Project #22-004
Costco Wholesale Warehouse
Located at approximately 1160 North 1000 West

Project Name: Costco Wholesale Warehouse
Proponent / Owner: Sean Anderson / Blue Springs Business Park
Project Address: Approx. 1160 North 1000 West
Request: Design Review & Conditional Use Permit
Current Zoning: Industrial Park (IP)
Type of Action: Quasi-Judicial
Hearing Date: Jan. 13, 2022
Submitted By: Russ Holley, Senior Planner

RE: Costco Wholesale Warehouse and Fuel Facility
NEC - North 1000 West and West 1000 North, Logan, Utah 84321
Project No. PC 22-004
Our Job No. 21873

Figure 3 shows the front (West) elevation.

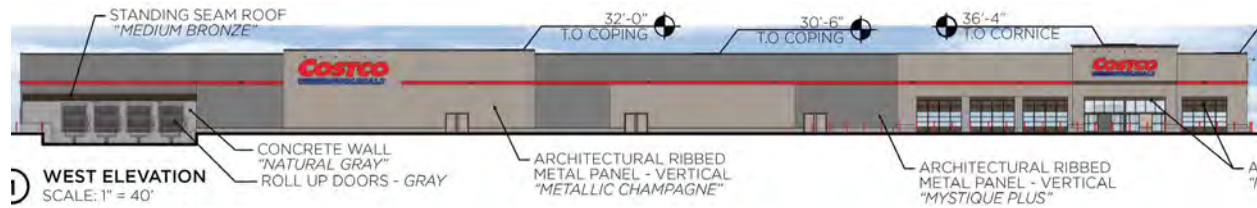
LDC 17.10.130 states that 30% transparency (windows, fenestration) is required on street facing front facades. LDC 17.43.080.C.5. allows decision makers to approve adjustments to aesthetic elements, such as fenestration, if the adjustments are consistent with the surrounding neighborhood character and won't compromise future similar approvals. With the IP zone allowing a wide range of uses such as offices, restaurants, hotels, etc., the 30% transparency is appropriate in those situations. However, the IP zone also allows uses such as warehousing, manufacturing and freight movement, etc., where 30% transparency is impractical and unrealistic. It is for this reason, the LDC gives flexibility to decision makers on aesthetics issues like transparency. In this case, being a wholesale warehouse, the applicant is requesting a deviation from the 30% transparency. The building is proposed with approximately 10% fenestration around the entryway and a mixture of landscaping elements that are strategically placed along the west side as an alternative aesthetic measure. The existing character of the surrounding neighborhood is comprised of manufacturing (Gossner Foods) and warehousing with buildings significantly below the 30% transparency level. As conditioned, the building design meets the requirements in the LDC.

Generally, the proposed project complies with the LDC and meets the Conditional Use Permit requirements. The only design issue is that the proposed building does not meet the 30% transparency requirement on the front façade. The applicant has proposed an enhanced landscaping screen along the front façade to help provide additional visual interest and soften the building's exterior. The building is also located far enough back from the public roadway, that the fenestration loses its importance. Given the fact that this zone allows such a wide range of uses and the LDC specifically allows deviation from the aesthetically based standards in certain situations, staff is comfortable with this deviation and would recommend that the Planning Commission exercise its discretion on this specific issue and permit the reduction in the transparency. The deviation on this design issue for this specific project in this specific context does not create a precedence for future project reviews, nor does it constrain the Planning Commission in future actions, as any new project will need to be reviewed for code compliance based on the merits and conditions of that specific project.

1. All standard conditions of approval will be recorded with the Design Review and are available in the Community Development Department.
2. Transparency on the west façade shall be 30% unless the Planning Commission utilizes the authority given in LDC 17.43.080 to adjust this percentage.

Response: Costco's model as a warehouse retailer does not lend itself to fenestration and transparency like an office building does. In fact, one of the reasons Costco pursues sites in industrial zones is for the flexibility those zones often have for developments like theirs. For Logan, we have incorporated glass rollup and sliding doors at the main entry canopy and the tire center to provide as much transparency and fenestration as possible along both our west and south elevations. Unfortunately, that still only provides roughly 10 percent. However, Costco's development team (architects and landscape architects) have strategically placed trees and landscaping to mitigate for this lack of transparency. We have also selected high-quality architectural siding panels with rich colors and textures to break down the building into smaller components. Our site plan incorporates additional trees throughout the parking lot to enhance the landscape and provide an attractive, natural screen from the adjacent right-of-way frontage. This combination of landscape and architectural features is consistent with the style and materials used on adjacent large format developments, such as the Gossner Foods and future FedEx buildings located in the area.

① EAST/ WEST ELEVATION
SCALE: 1/8" = 1'-0"

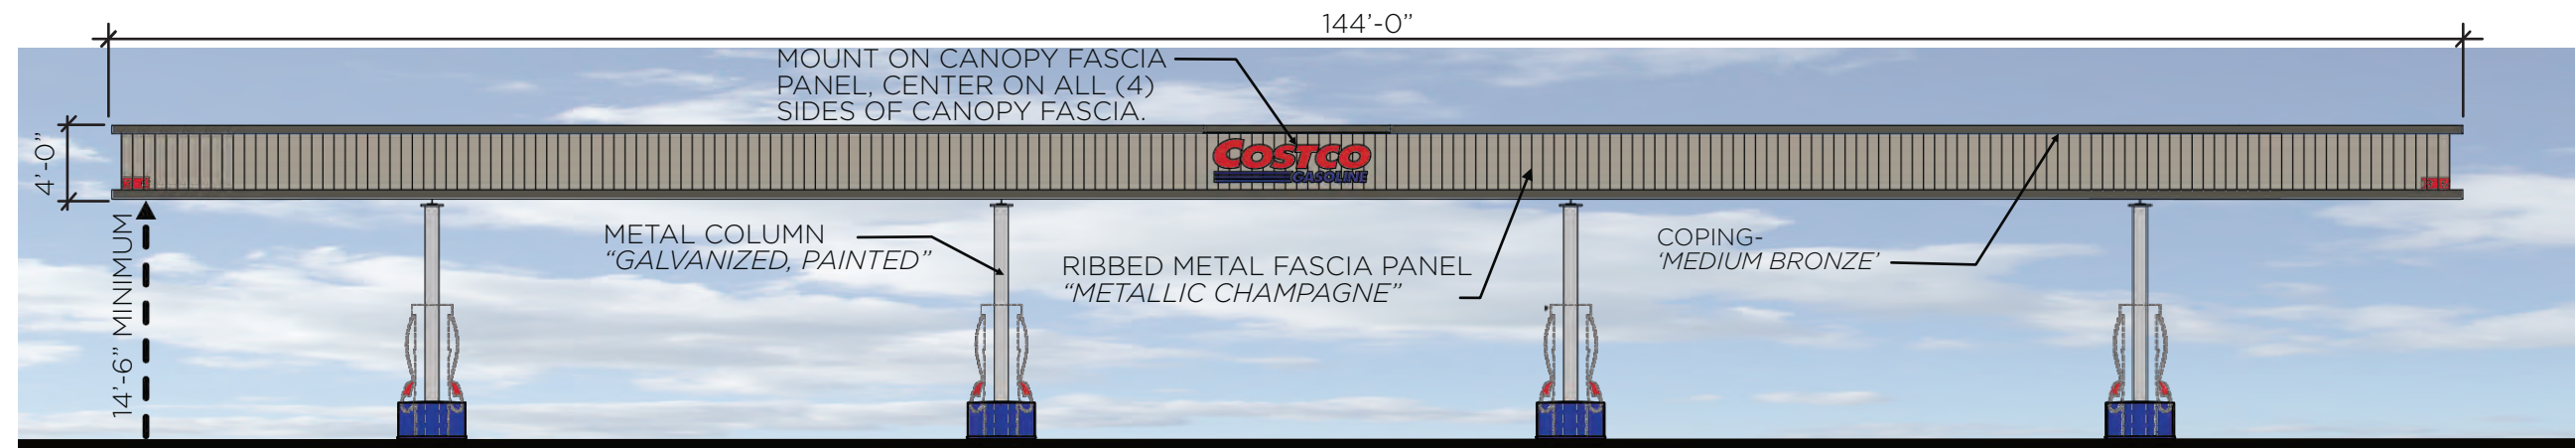
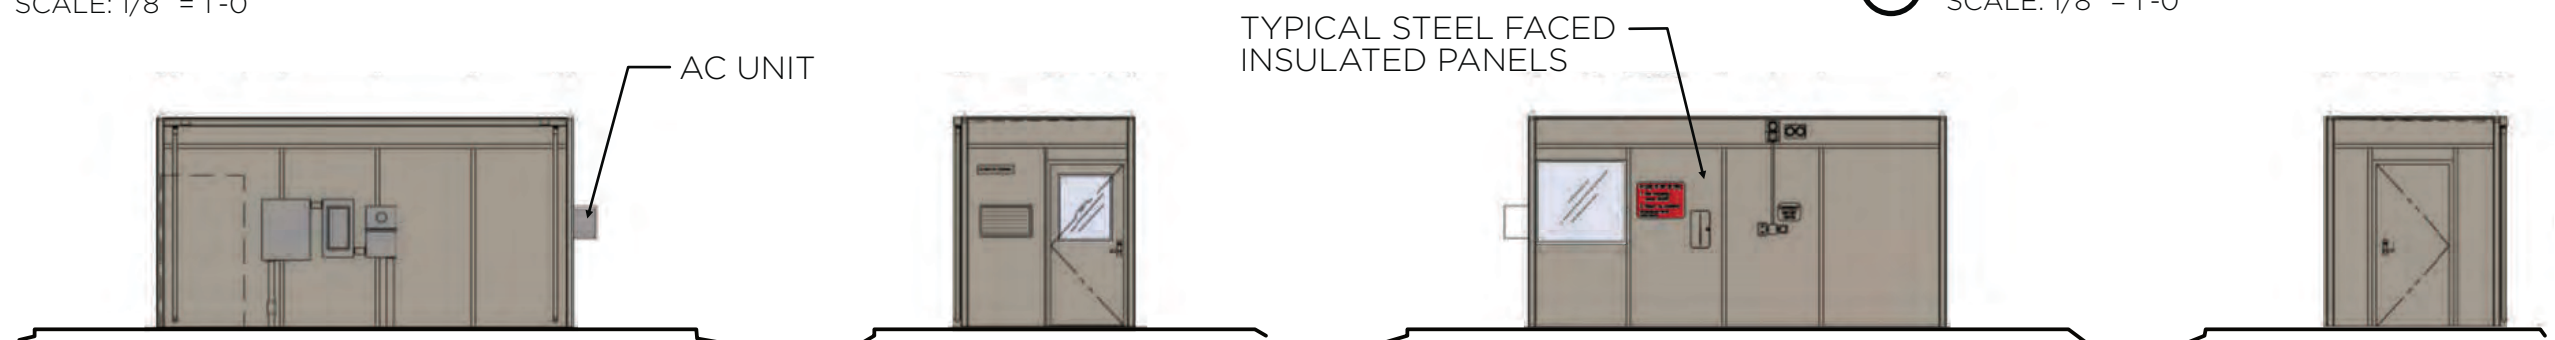
Bldg design = 30% ground floor transparency (will need to come up with alternatives like vertical landscaping etc...) – Bldg materials.
